# 20-VARIANCE-0037 Vine Street Variance

Louisville Metro Board of Zoning Adjustment
Public Hearing

Zach Schwager, Planner I June 8, 2020

#### Site Plan

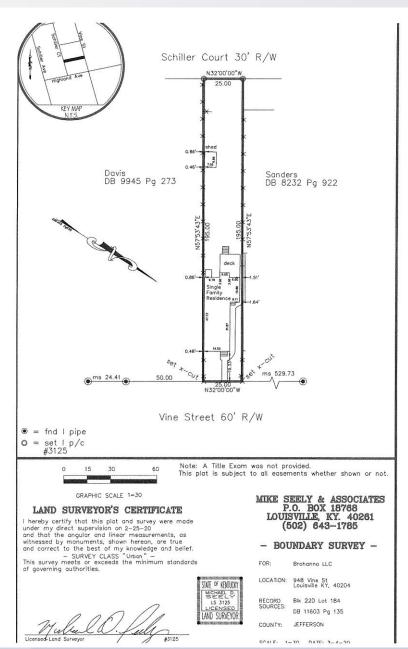
The existing structure is one-story and the applicant proposes to add a second story to the entire existing footprint. The proposed second story addition will encroach into the setbacks on both sides.

#### **Elevations**

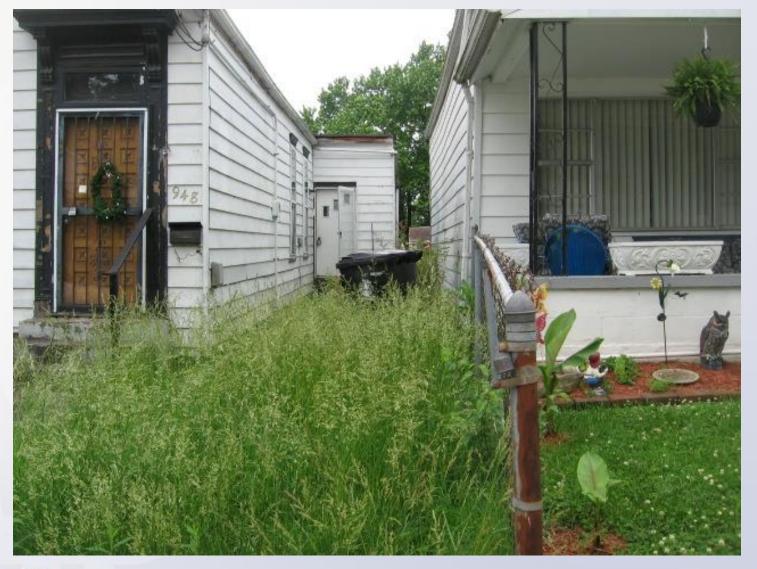
Louisville Variance location for the northern side from the front.

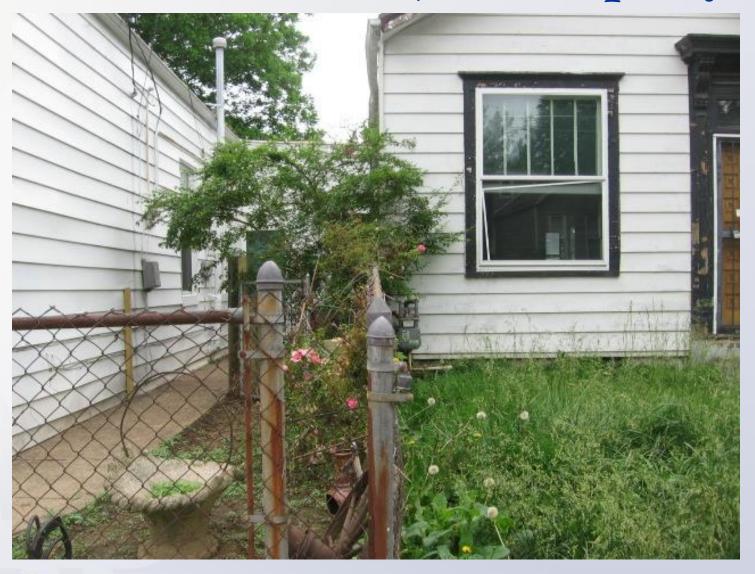
Louisville Variance location for the southern side from the front.
